From: Emma Rogerson
Sent: 19/07/2022 6:01:46 PM
To: Council Northernbeaches Mailbox
Cc: Team; Peter; Julia Wright
Subject: DA/2022/0906 - 3 Cootamundra Drive, Allambie Heights - Submission
Attachments: Submission - 3 Cootamundra Drive, Allambie Heights.pdf;

**Submission in regards to DA2022/0906 Development Application
3 Cootamundra Drive, Allambie Heights**

“Demolition works and construction of a dwelling house including the refurbishment of an existing swimming pool.”

Figure 3 – Overlooking Diagram

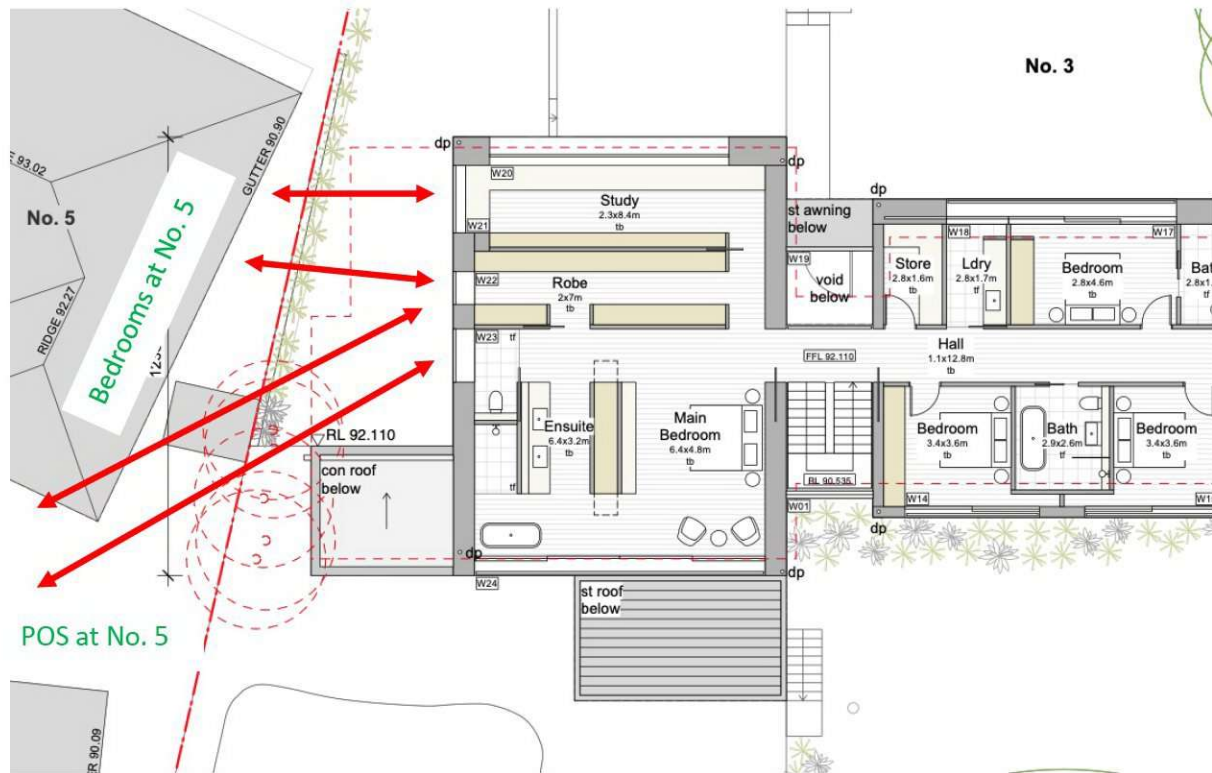
Windows along the north-western elevation marked as W21, 22 and 23 proposed under DA2022/0906 will allow for direct, unobstructed and close views into the principle private open space in the rear garden and sensitive bedrooms of 5 Cootamundra Drive. Figures 3 and 4 show the windows of concern and the proposed direction of overlooking, resulting in a substantial and unacceptable visual privacy breach.

- a) **Action:** Remove, frost or raise the window sill height to 1.7m of proposed windows No. 21, 22 and 23 (upper floor north-west facing windows).
